**CAER Carbon Fiber Development**  
**Project # 2543.0**  
**ADDENDUM # 2**  
09/16/2024

## ADDENDUM NUMBER TWO

# UK CAER-CARBON FIBER DEVELOPMENT FACILITY

CODE REVIEW PLAN  
C-0  
1/8" = 1'-0"

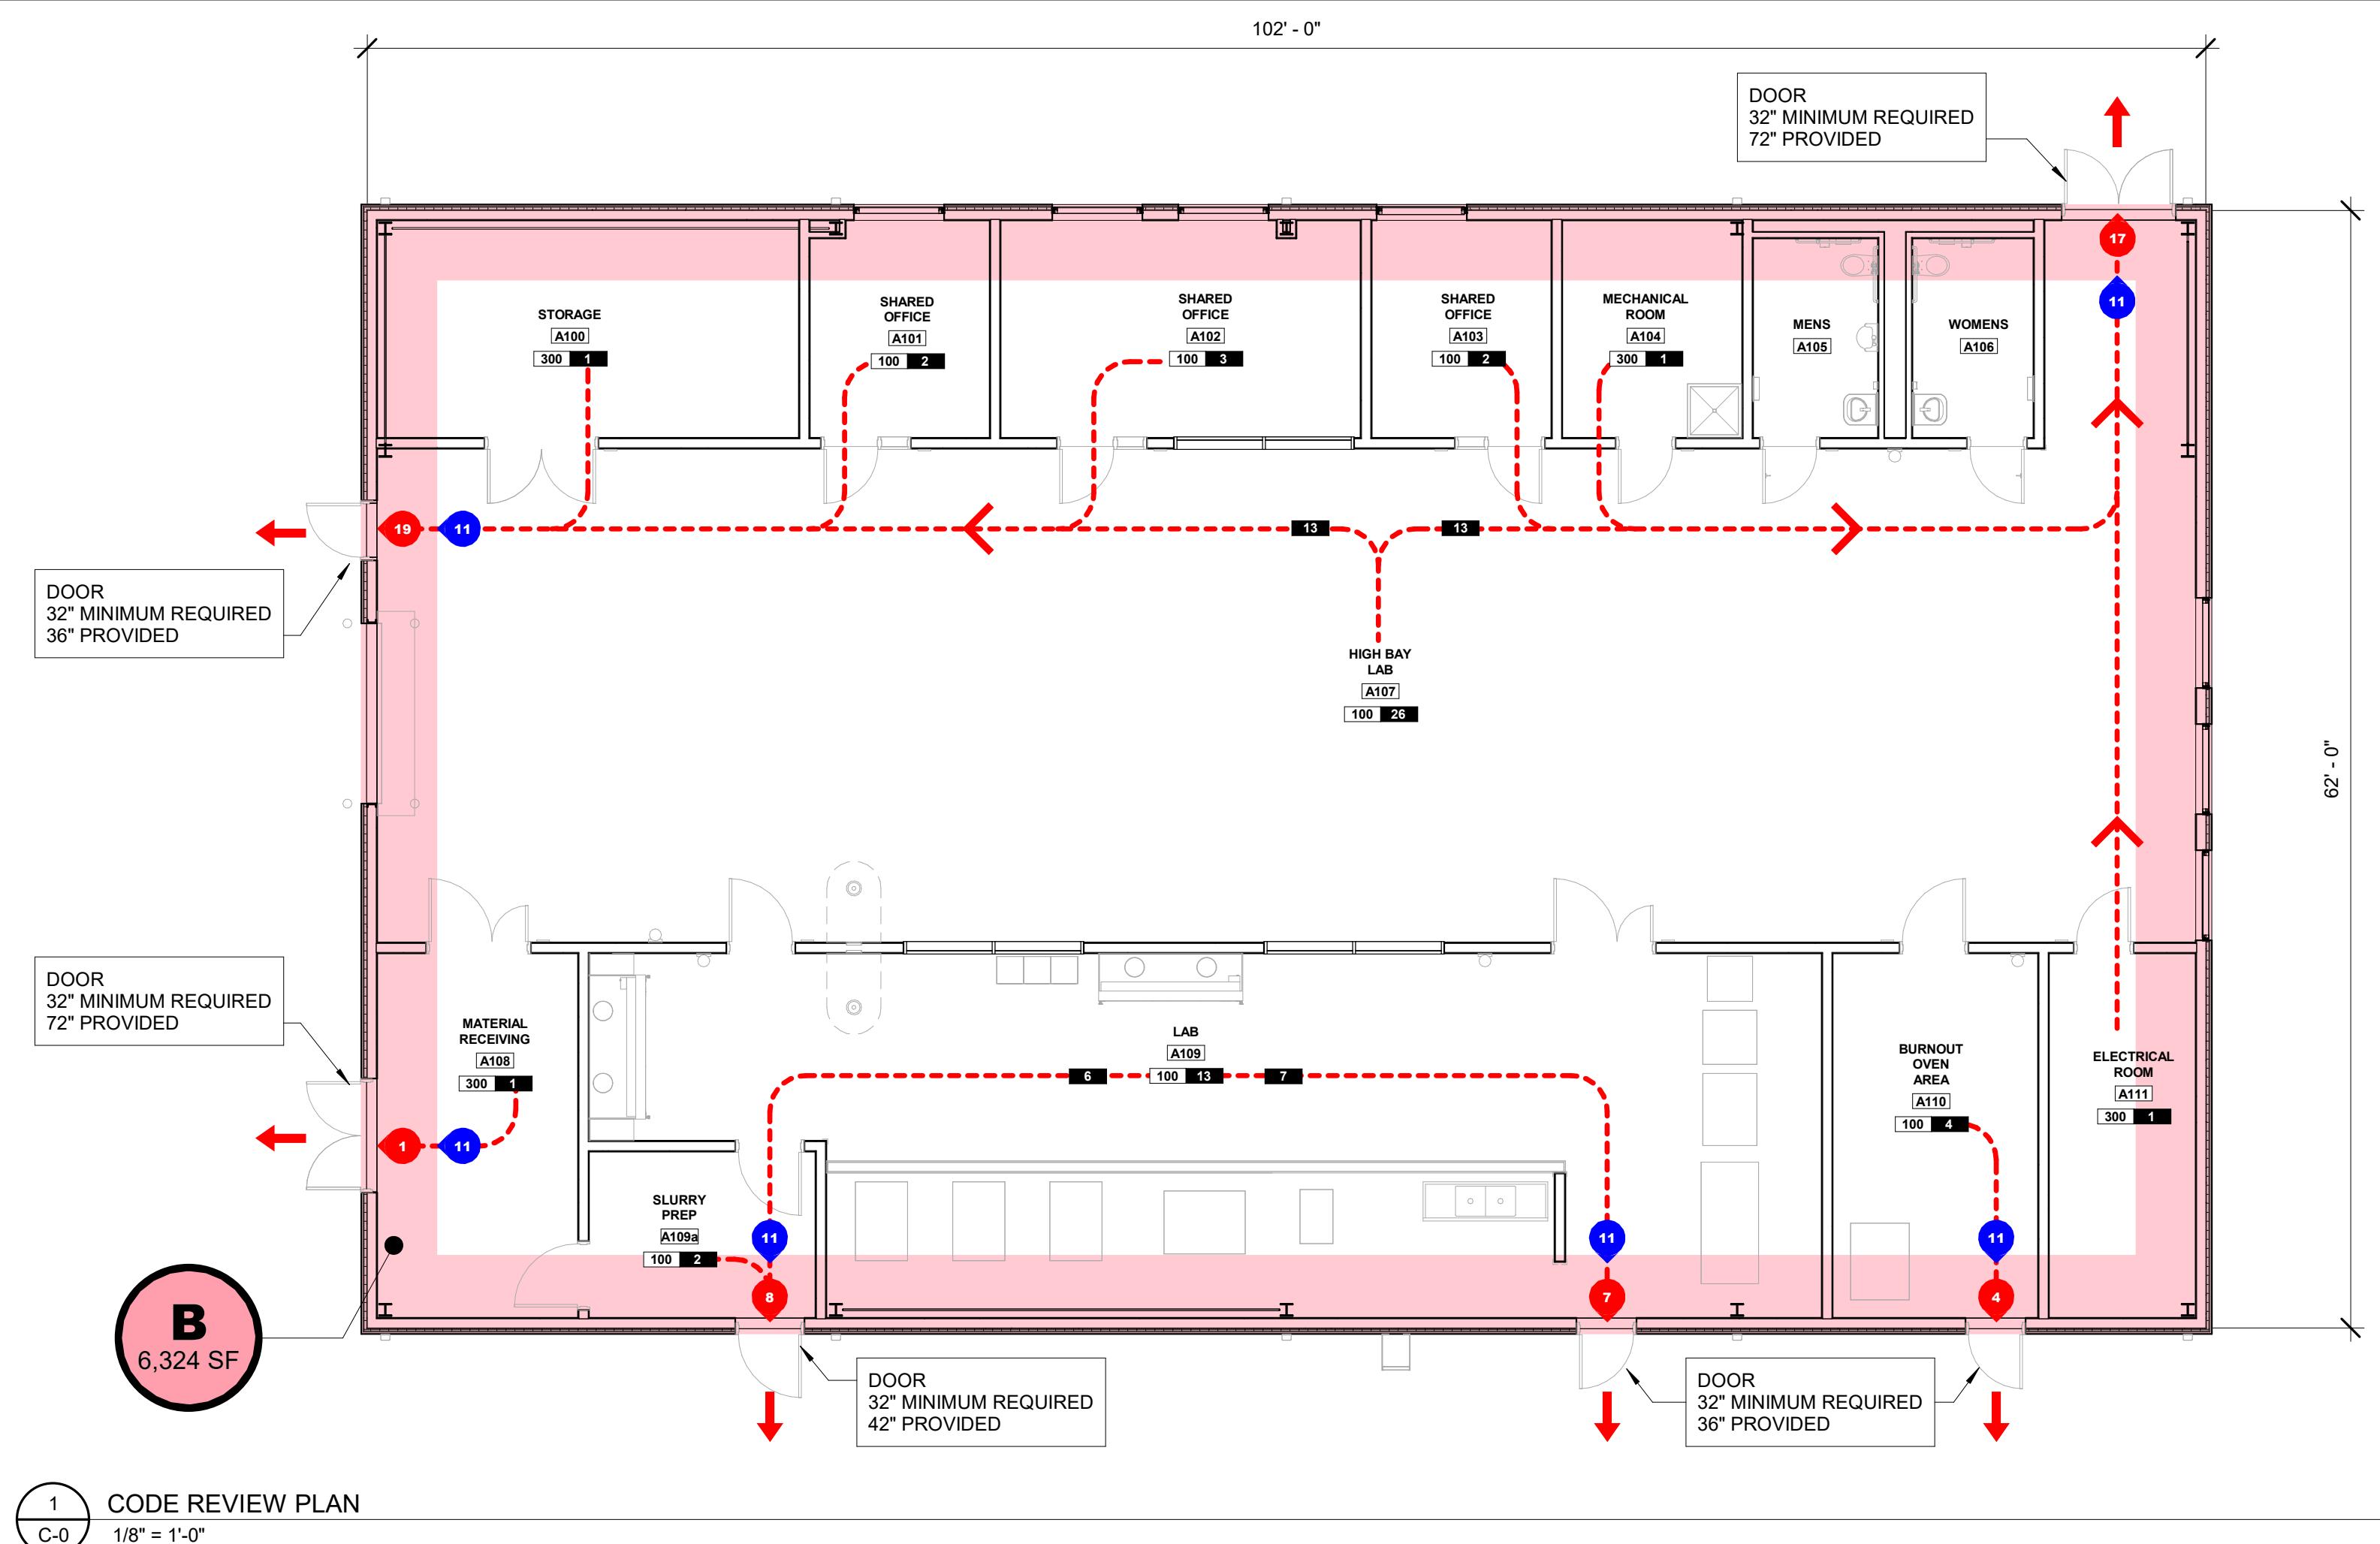
- Reference Cover Sheet:** Contractor to follow site diagram which indicates project location, entrance to the job site, and contractor parking/lay down area.

FIRST FLOOR PLUMBING  
PLAN

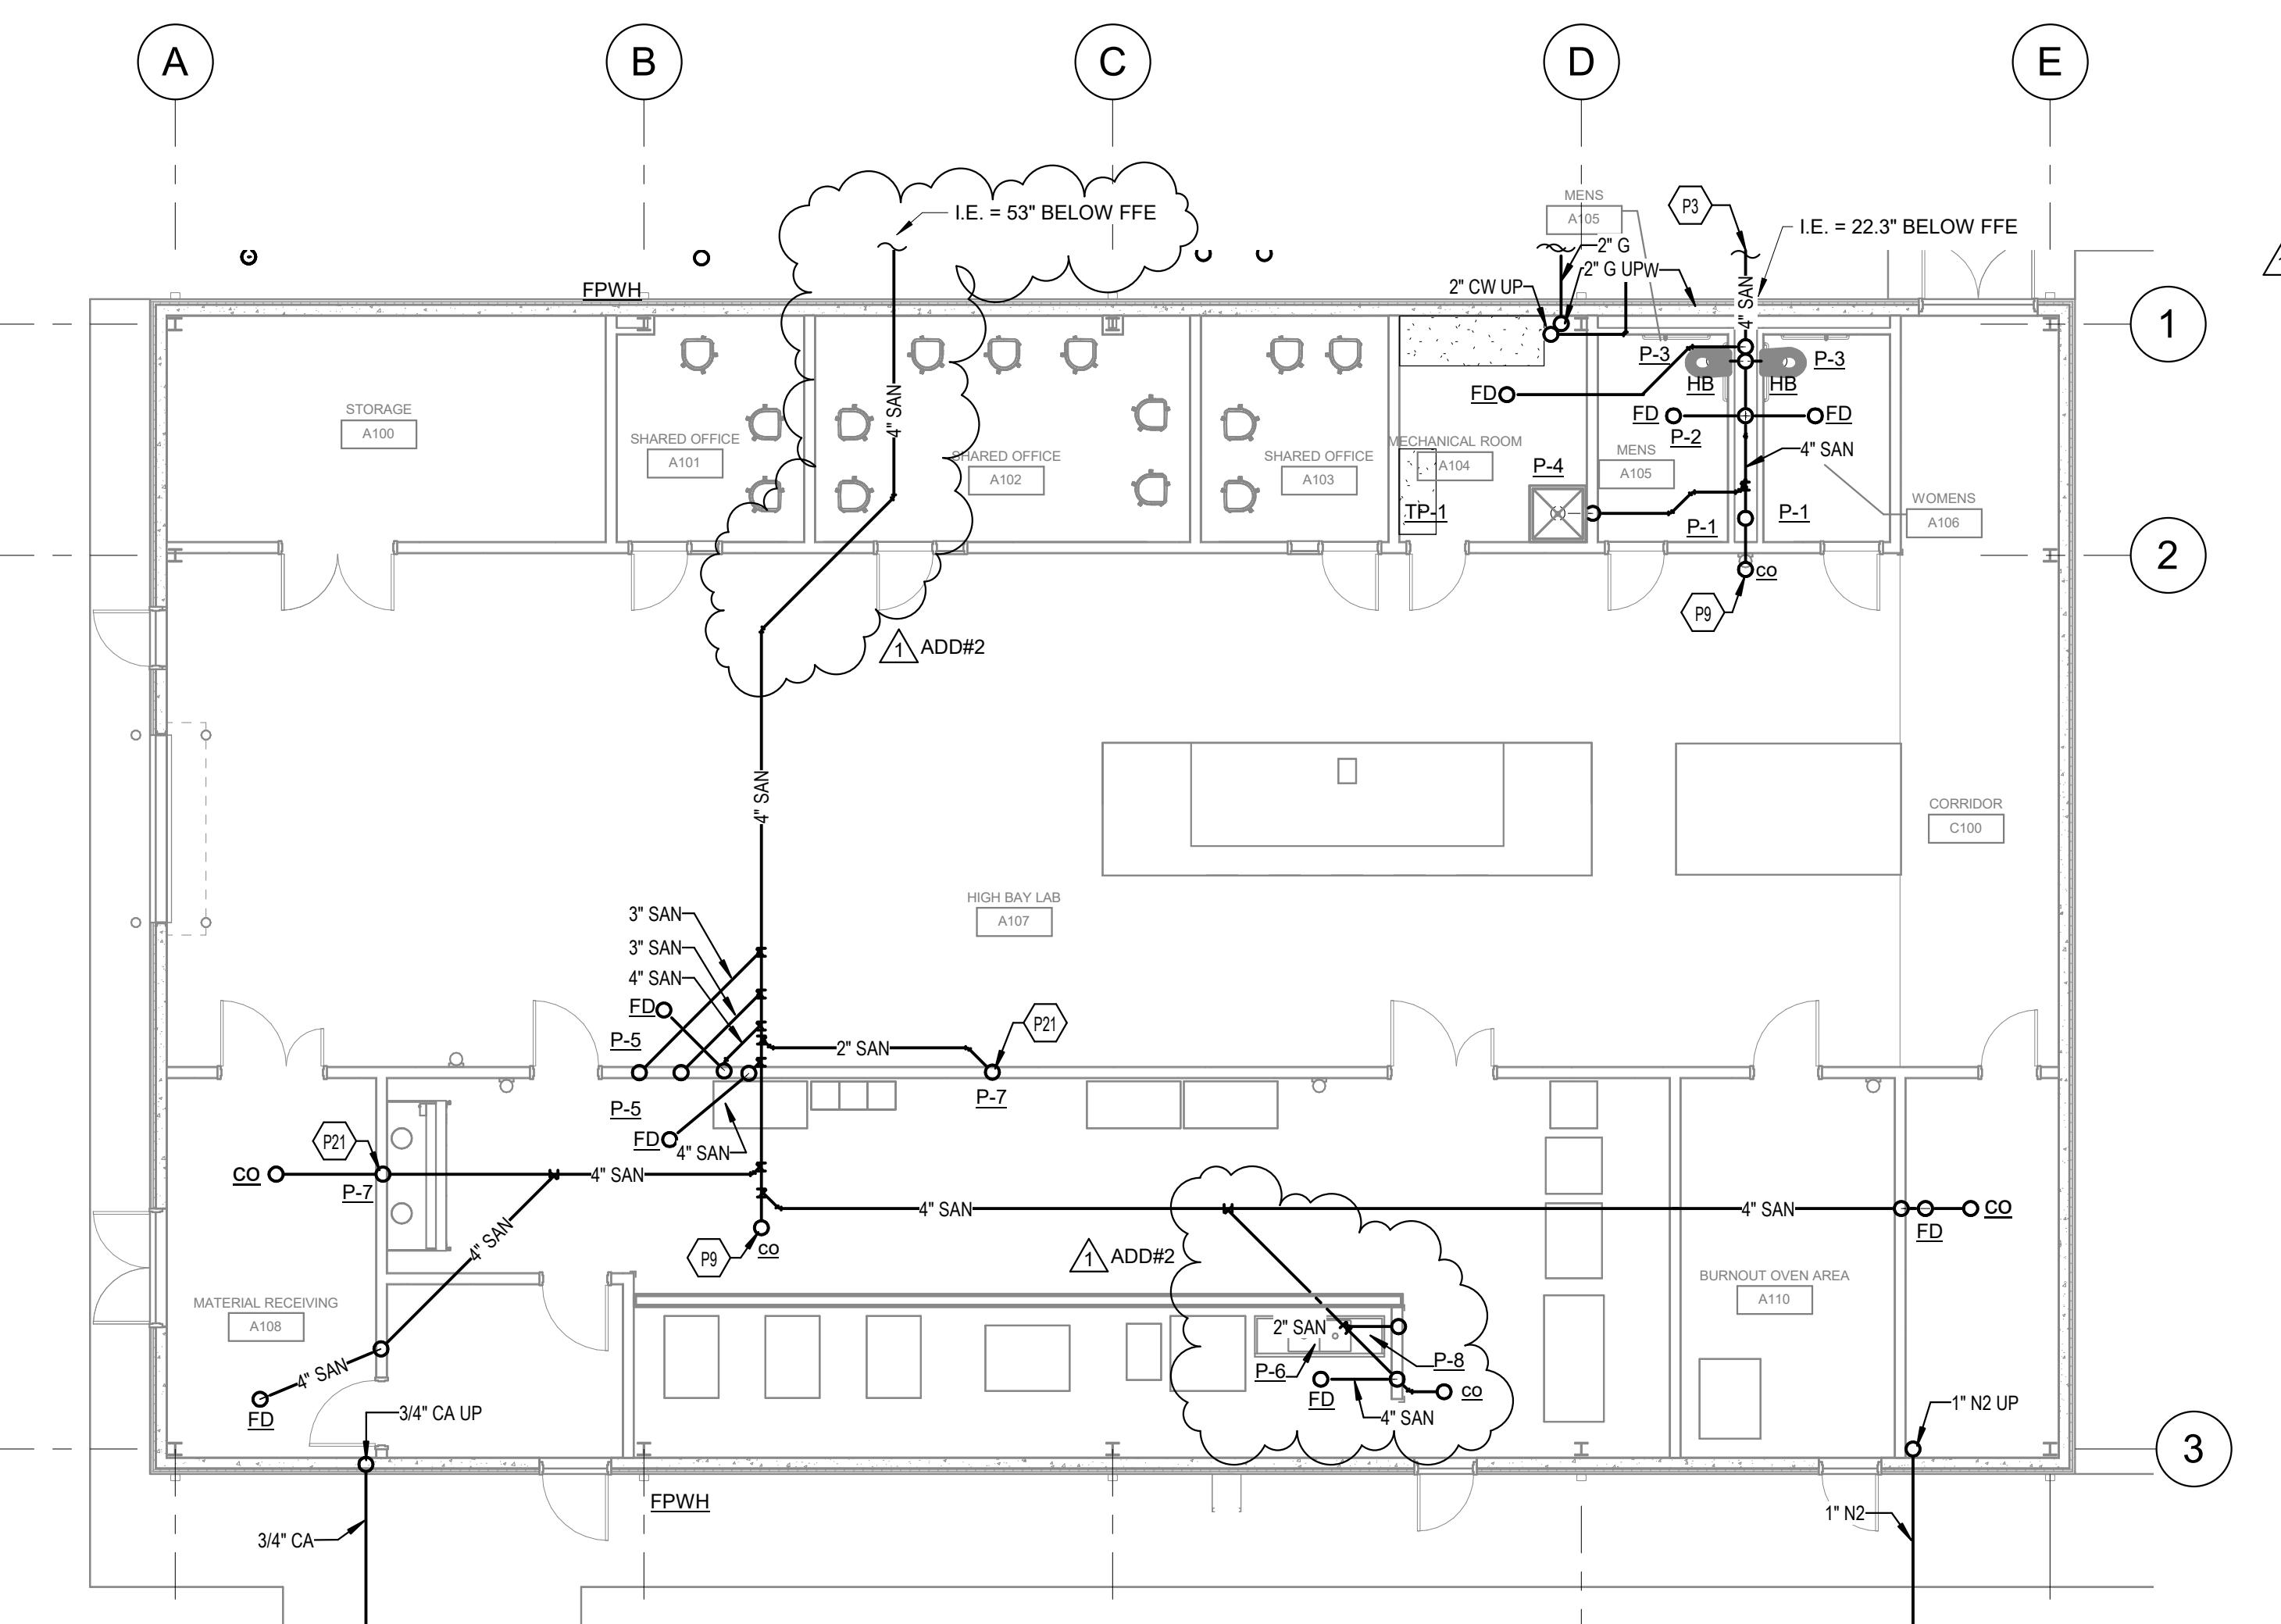
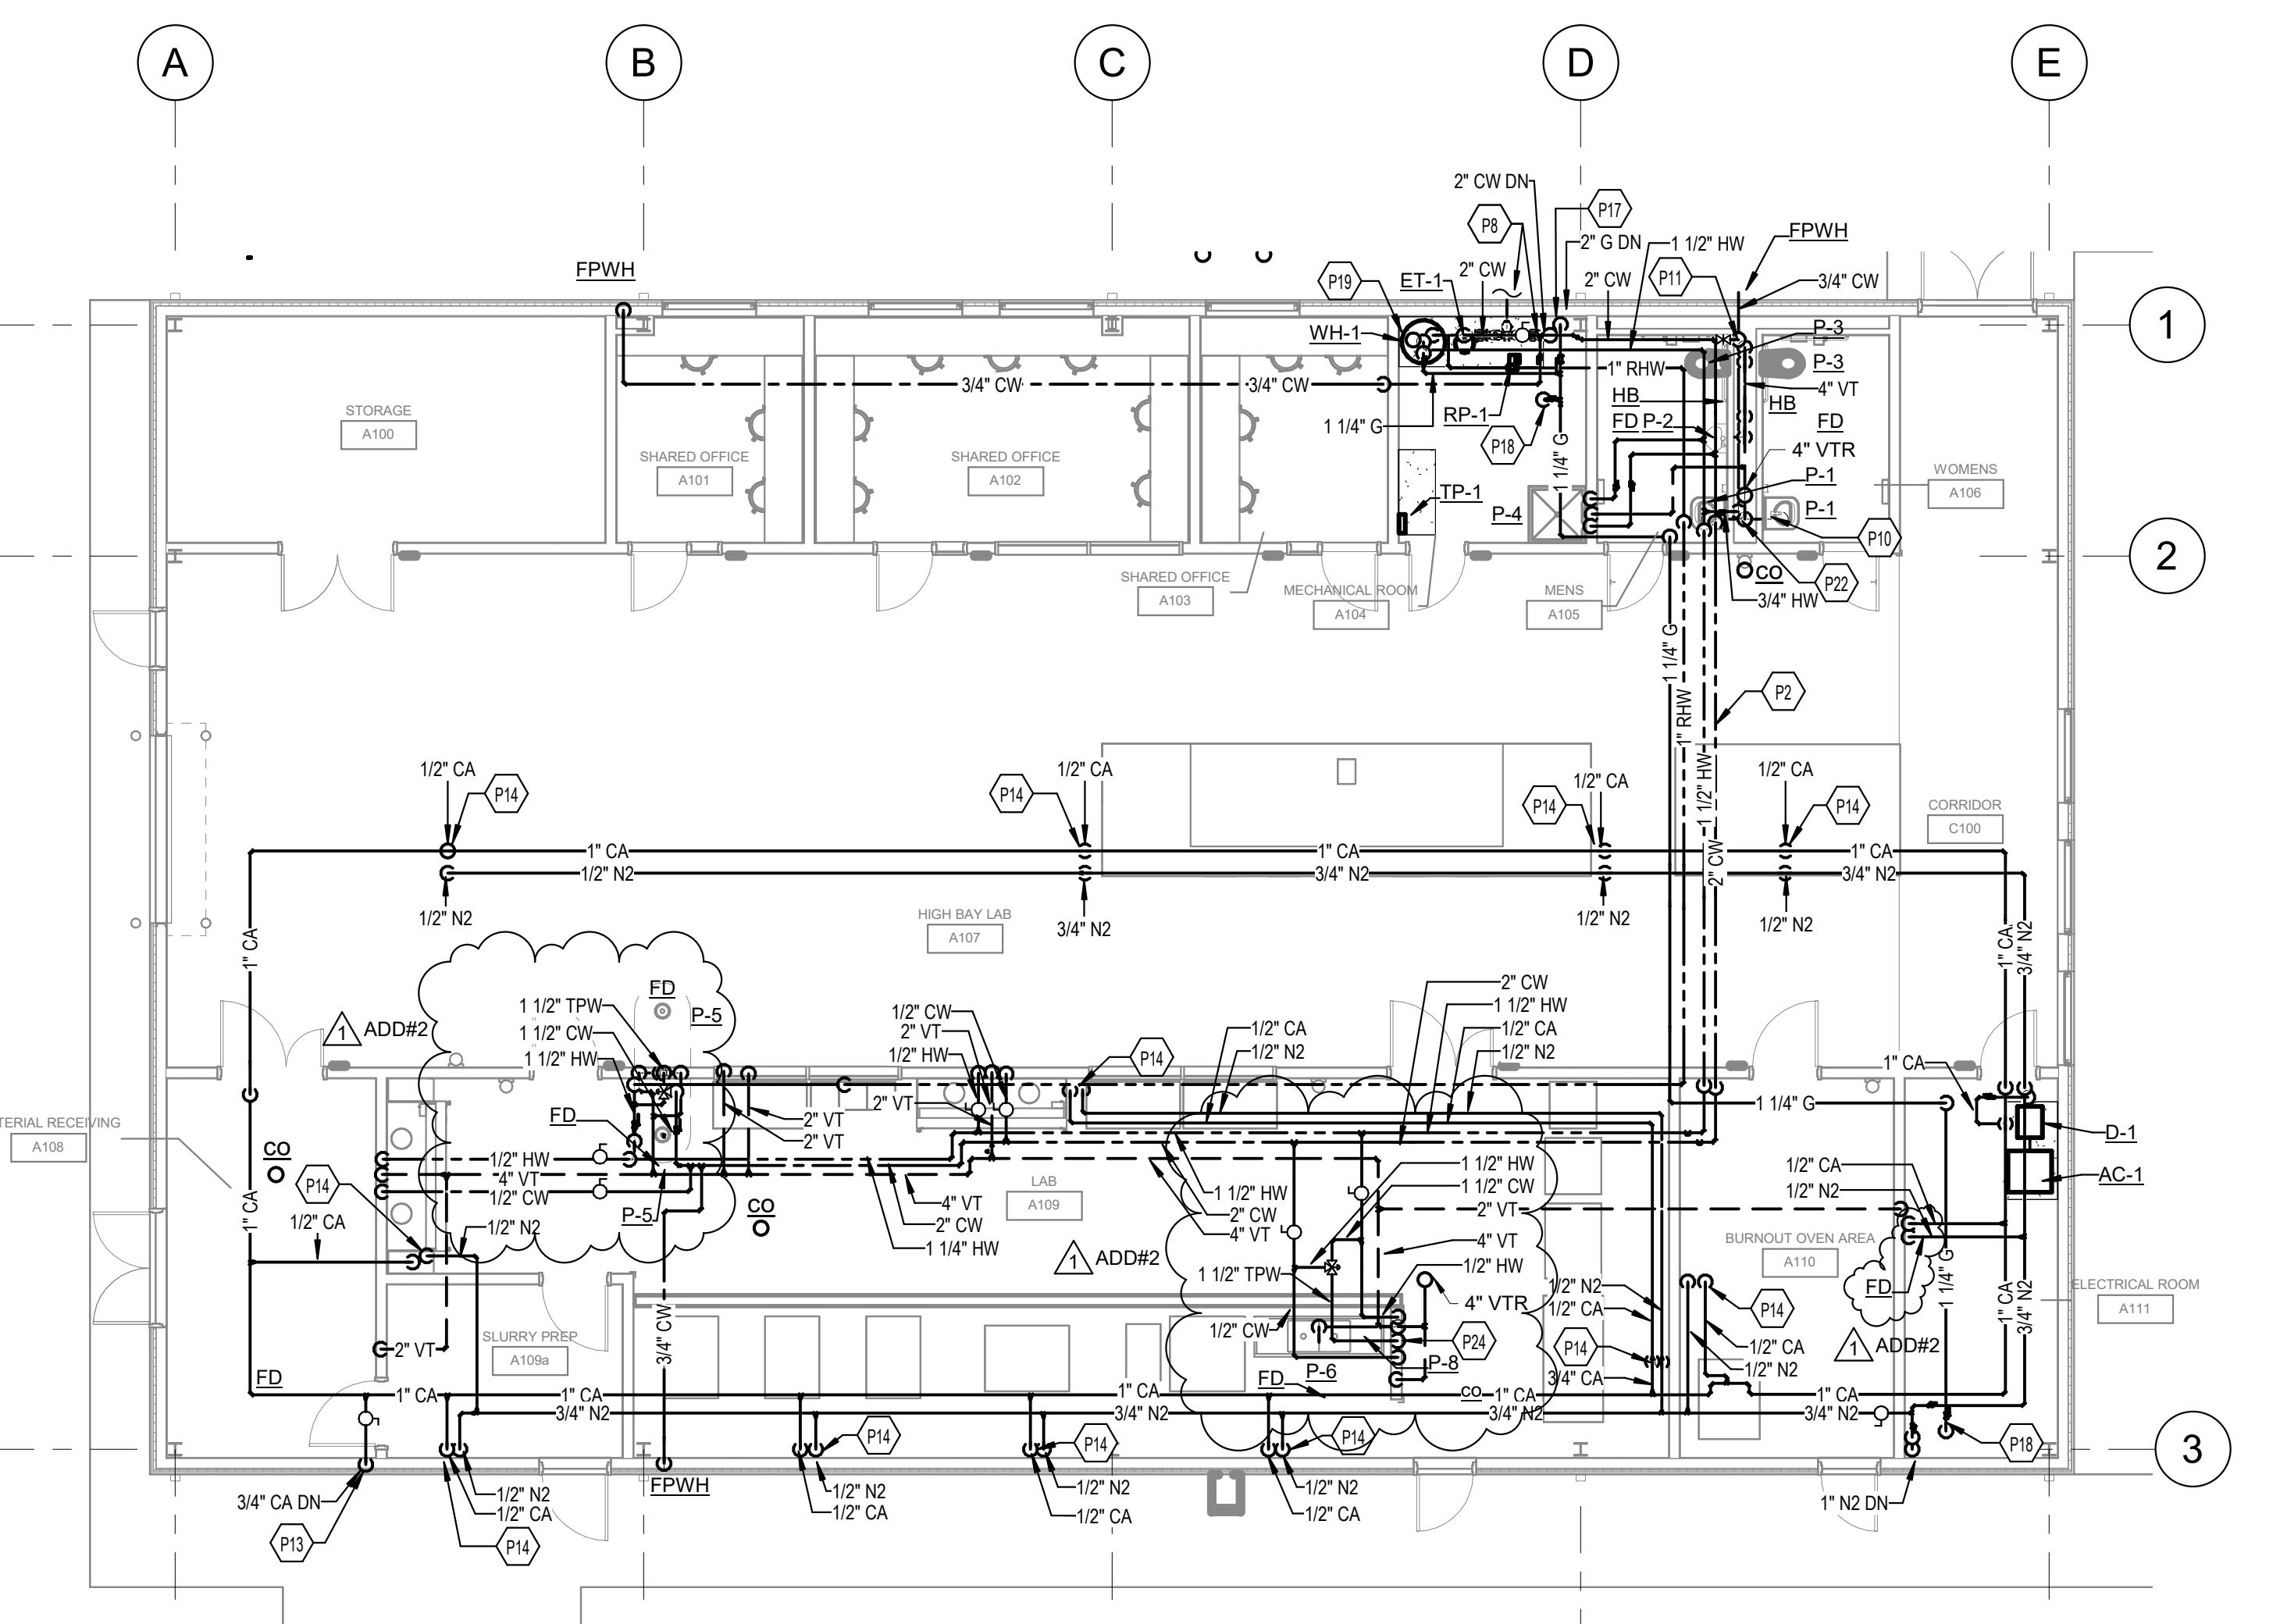
7. Refer to the Plumbing Drawings, Sheet P2.0 – FIRST FLOOR PLUMBING PLAN: Added deck mounted emergency eye wash/drench hose, floor drain, cleanout, and associated plumbing piping. Refer to clouded revision on sheet. Revised tagging for better clarity. Refer to clouded revisions on sheet.
